# Video Products Technical Bulletin 30-2005-059

SUBJECT: **REUSE PARTS WHEN REPLACING EB OR EC BOARD ON EA BOARD**

MODEL: **BVM-1915**  
**BVM-2015P**

**Figure 1**

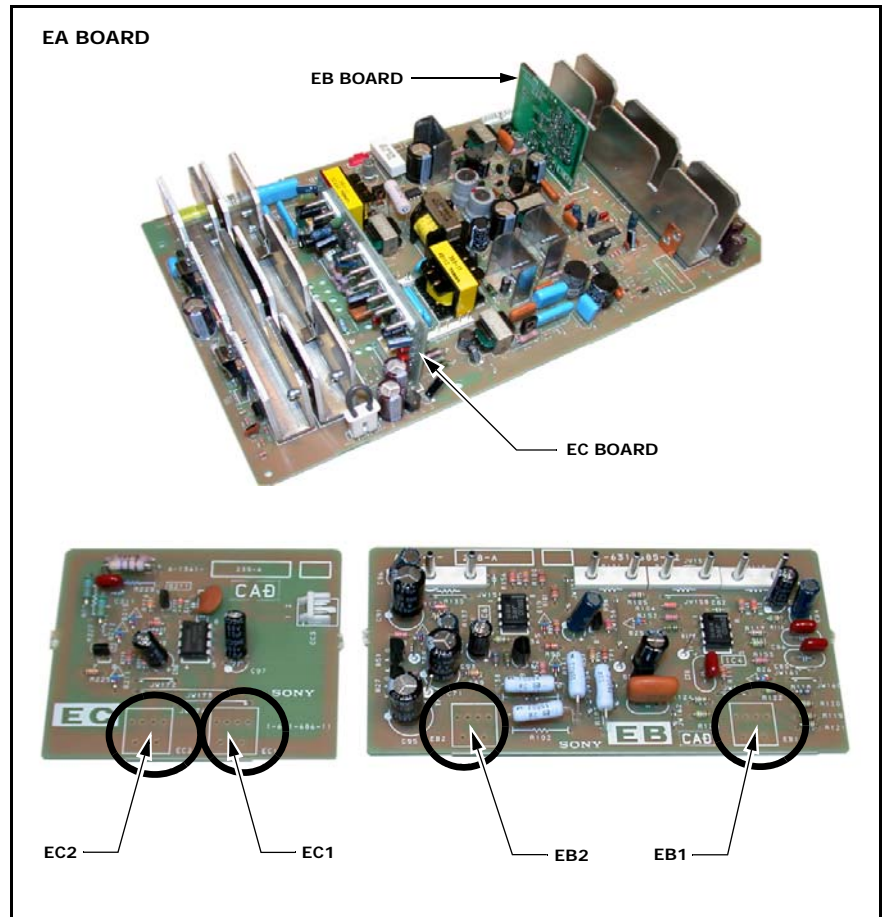
When you replace the EB or the EC board on the EA board (A-1345-881-B), remove the following parts from the former board and install them on the new board.

The new EB and EC boards do not contain the parts, and the parts are no longer available. (See Figure 1.)
